# HISTORIC AND DESIGN REVIEW COMMISSION

Agenda Item No: 23

**HDRC CASE NO:** 2015-094  
**ADDRESS:** 1203 E CROCKETT ST  
**LEGAL DESCRIPTION:** NCB 1373 BLK 1 LOT E 49 FT OF 9 & 10  
**ZONING:** RM4 H  
**CITY COUNCIL DIST.:** 2  
**DISTRICT:** Dignowity Hill Historic District  
**APPLICANT:** Aurora Morales  
**OWNER:** Aurora Morales  
**TYPE OF WORK:** Construct front porch, window modifications and front door installation  
**REQUEST:**

General Notes:

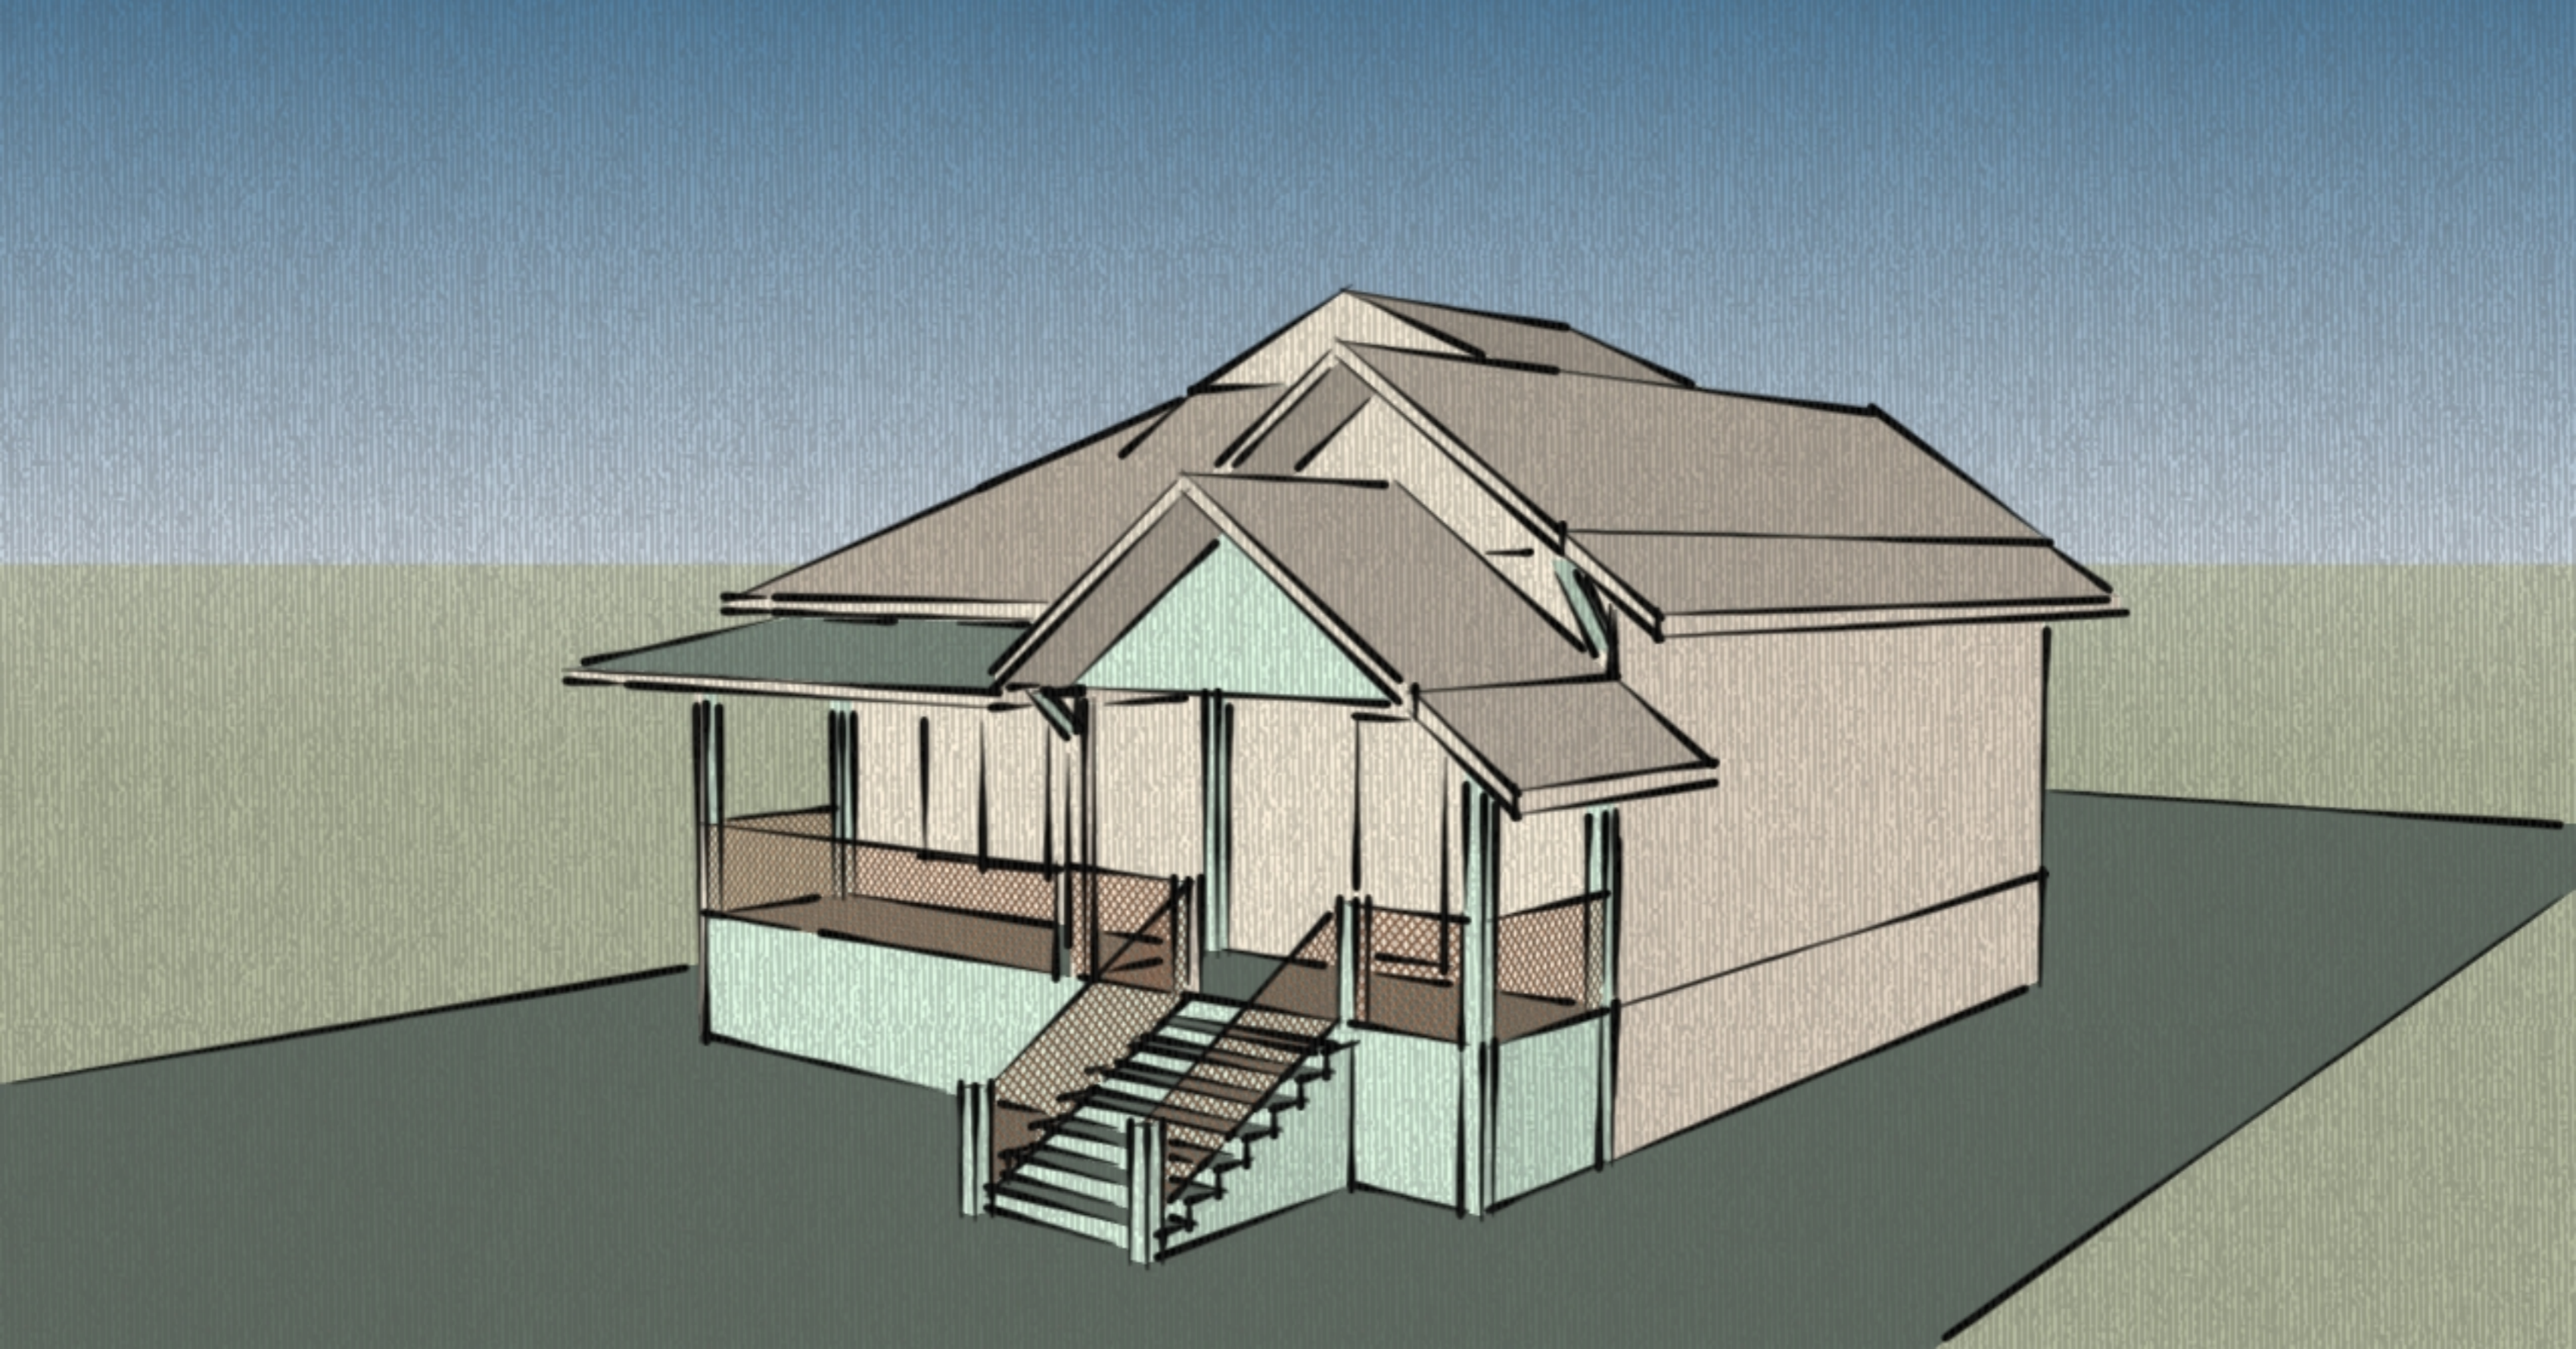
- e. Consistent with the Guidelines for Exterior Maintenance and Alterations, existing window openings should be preserved. In addition, non-historic windows should be replaced with new windows that are typical of the architectural style of the building. Although the proposed window modifications will alter the existing window opening, this opening is not of historic age and the proposed enlargement will not cause an adverse effect. However, the proposed multi-light windows are not typical of the Craftsman style and are not consistent with the guidelines. Using one-over-one wood windows would be more appropriate.

- h. The Guidelines for Exterior Maintenance and Alterations recommend that doors are replaced in-kind when possible when deteriorated beyond repair. The proposed front door is not in keeping with the architectural style of the home and is not a commonly found type of door in a historic district.

1. Staff recommends approval of item 1 based on findings a-g with the stipulation that the new windows are one over one wood.
2. Staff does not recommend approval of item 2 as submitted based on findings h. Staff recommends that a historically appropriate front door is installed or that a wooden screen appropriate for the style of the house is used instead.
